ADDENDUM #3

3 April 2026

RE: Maize USD 266 – Bus Storage Building

Project #: 5537.50

A ROOF PLAN - VEHICLE STORAGE (ALTERNATE SHOWN)
1/8" = 1'-0"

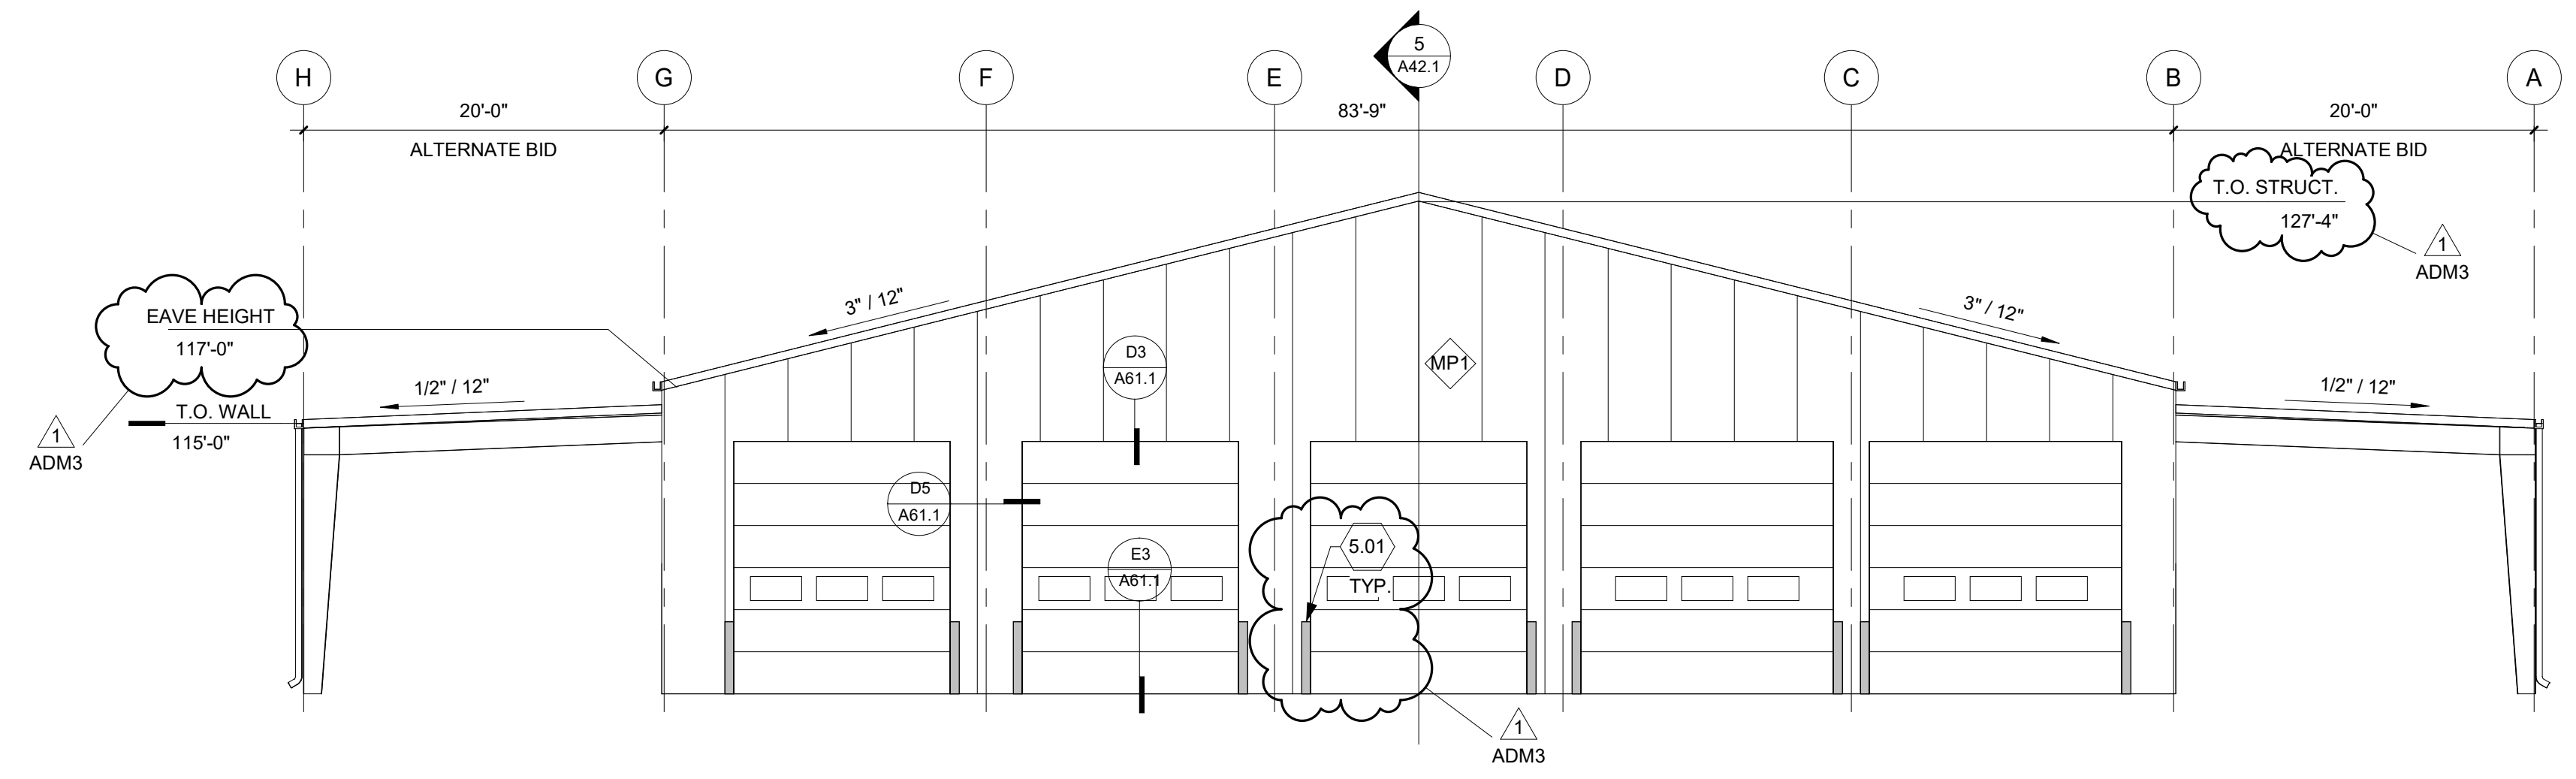
Item AD3-A05 Drawing Sheet A24.1 – Roof Plan:

ADDITION: Add snow guards to all roofs; 2'-0" up the slope from the gutters. Ref. attached Drawing Sheet A24.1.

- 7.11 PRE-FINISHED 24 GA. METAL GUTTER - REF. DETAILS
- 7.32 ICE GUARDS; 2'-0" UP THE SLOPE FROM THE GUTTER. REF. SPEC.

A EAST ELEVATION - VEHICLE STORAGE
1/8" = 1'-0"

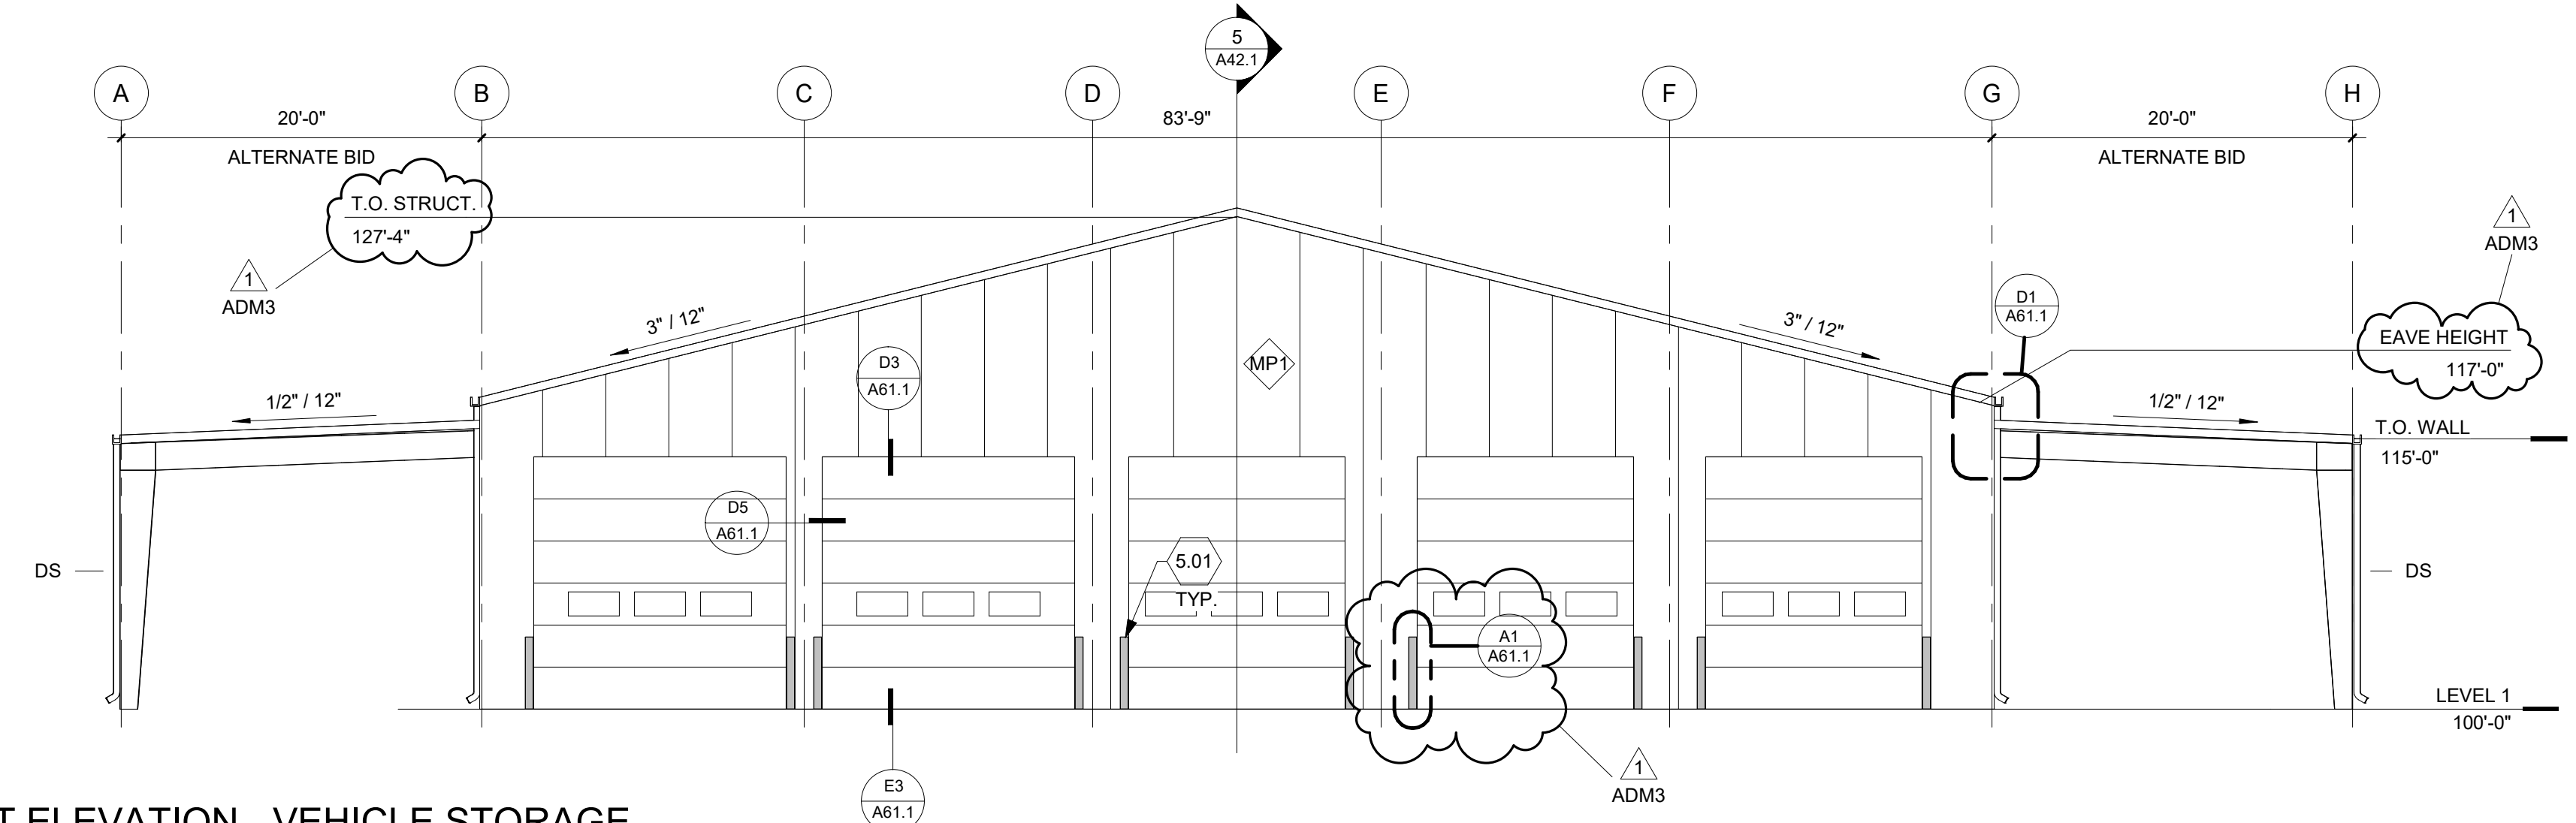
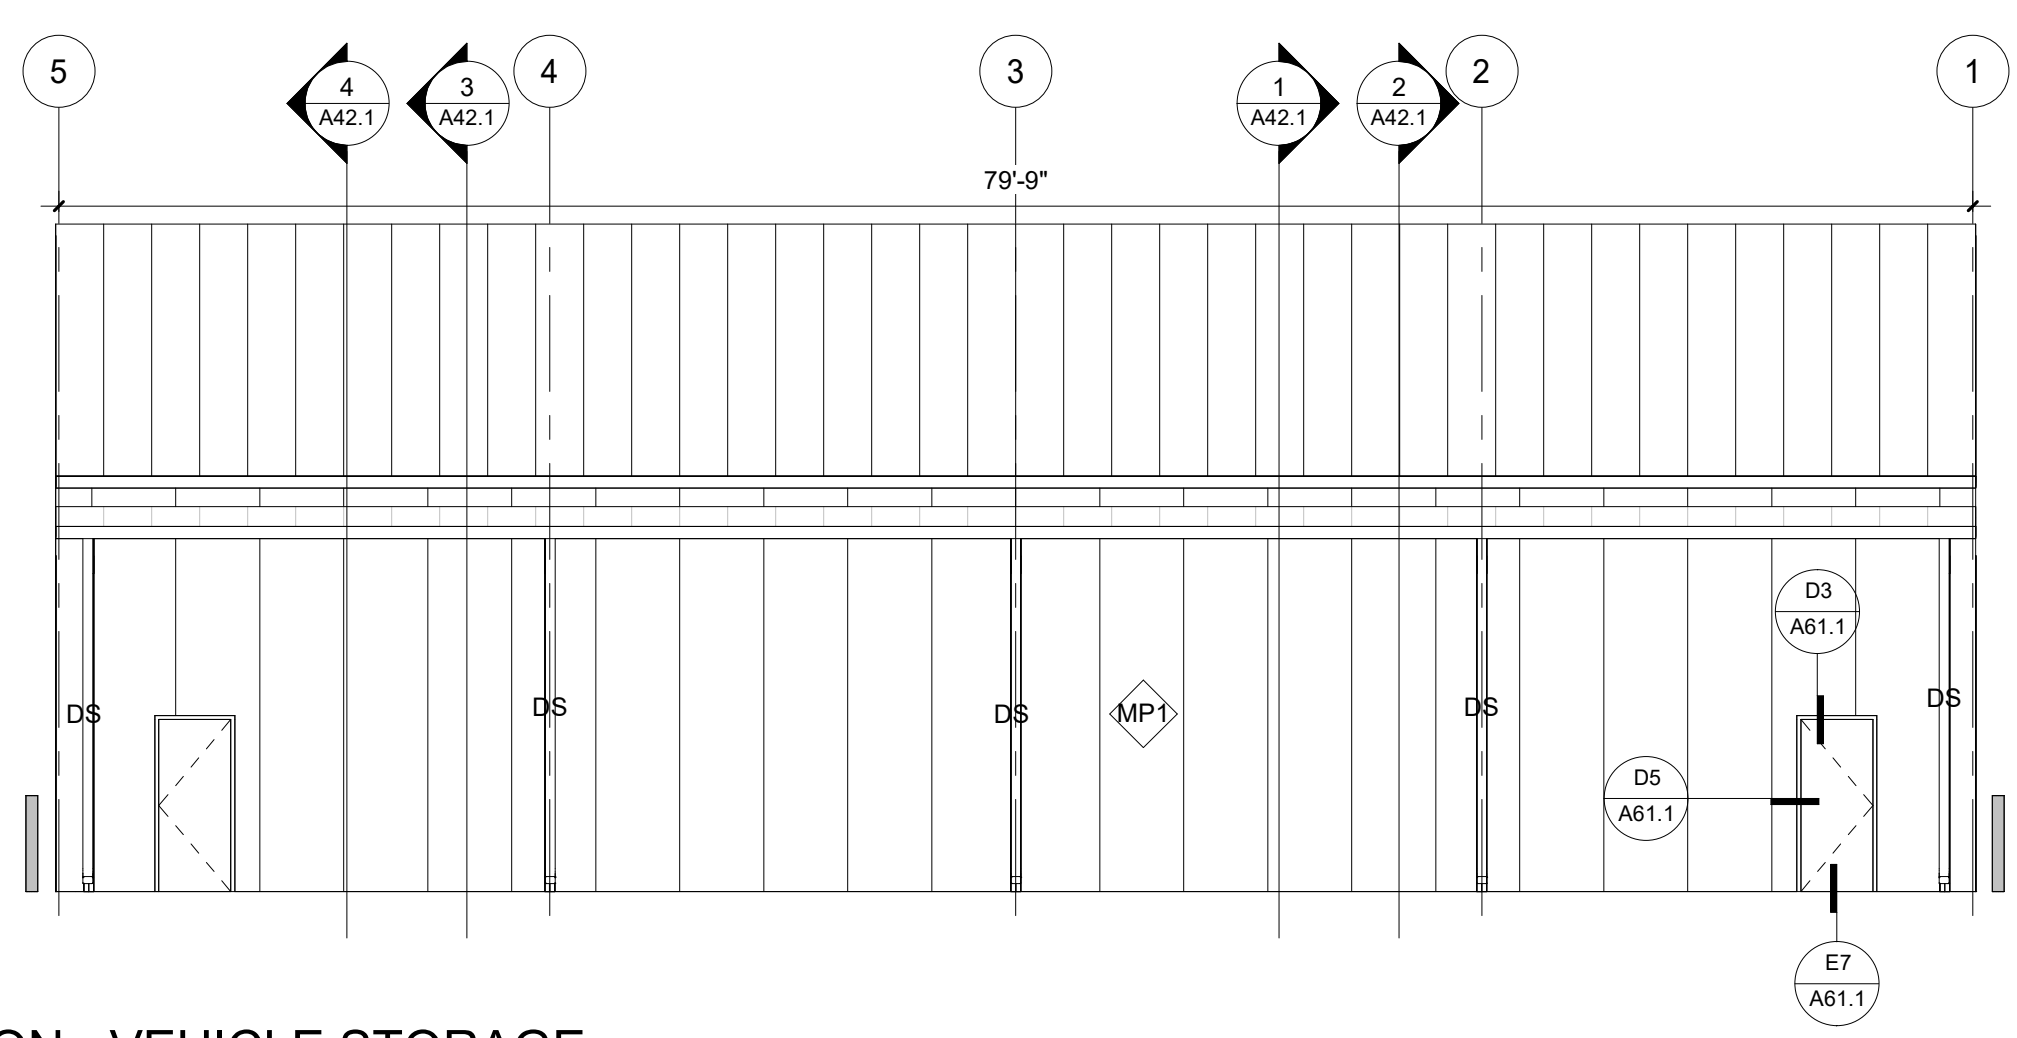
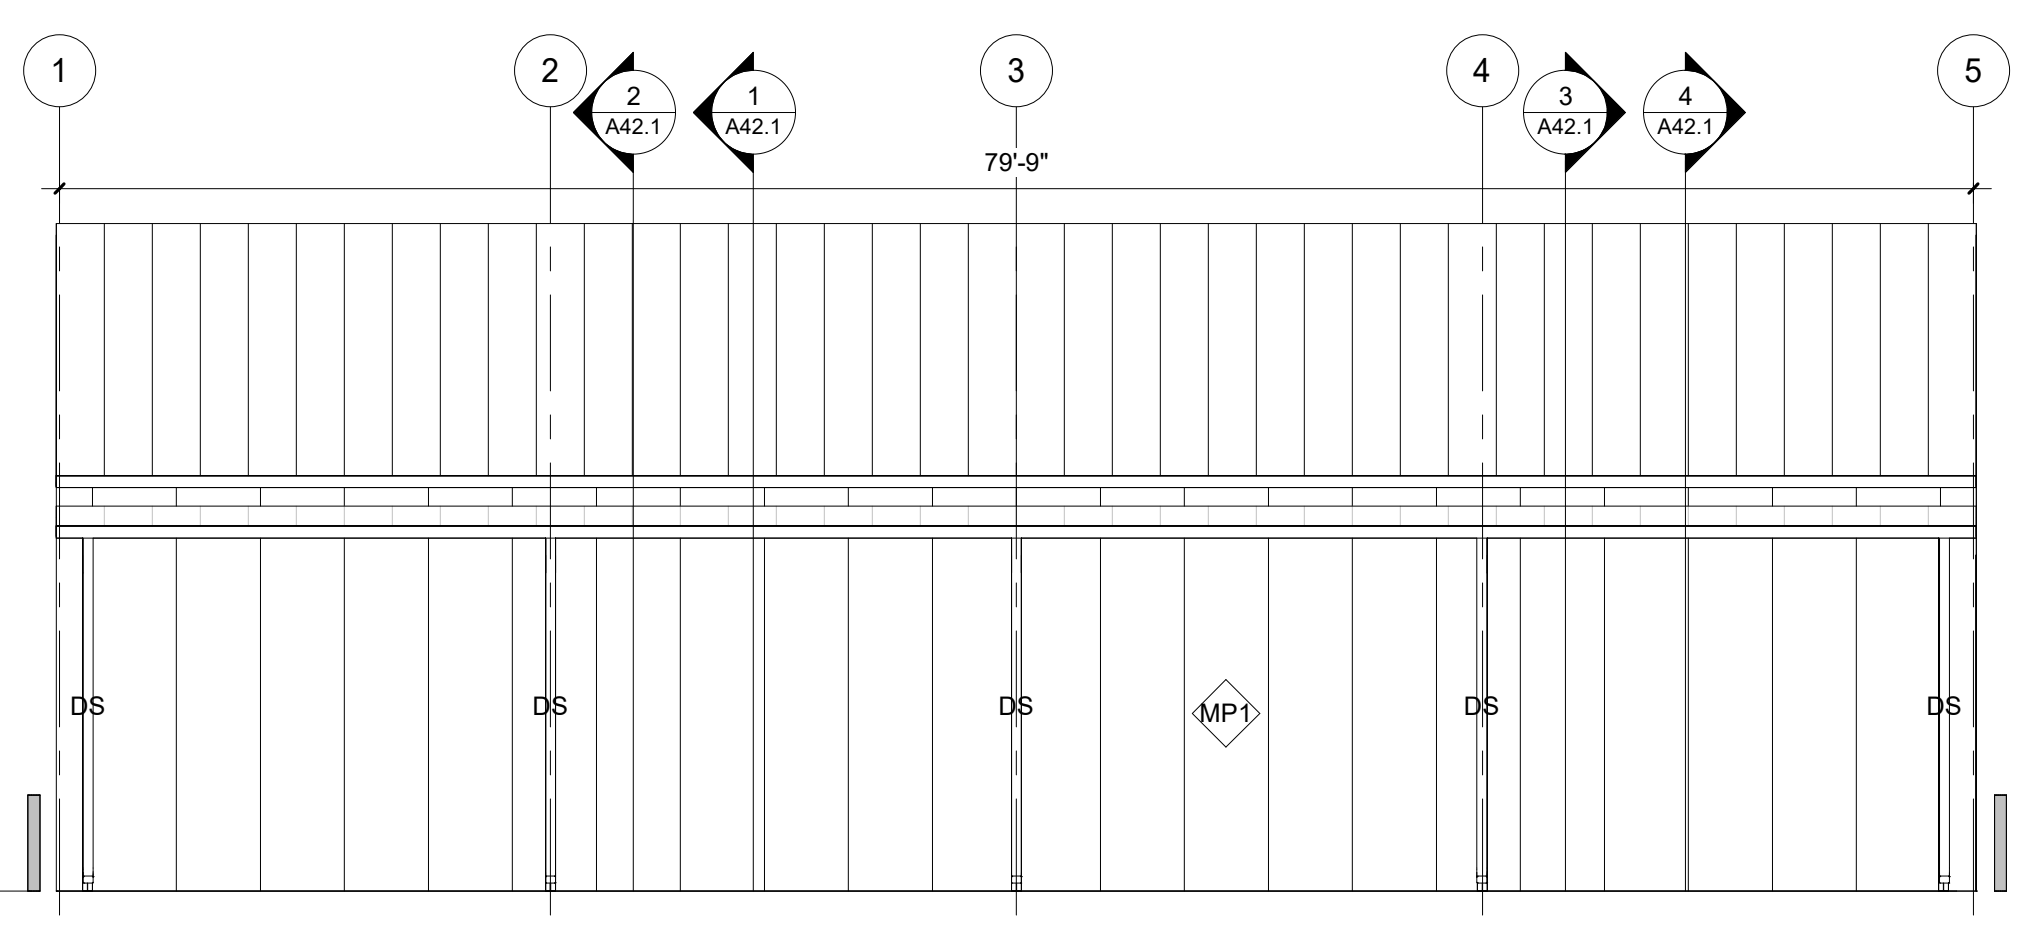
Item AD3-A06 Drawing Sheet A32.1 - Elevations:

REVISION: Raise the eave height of the main building to 117'-0". Ref. attached Sheet A32.1.

ADDITION: Alternate #1 – include gutters on the main building and on the low slope lean-to roofs (Alternate).
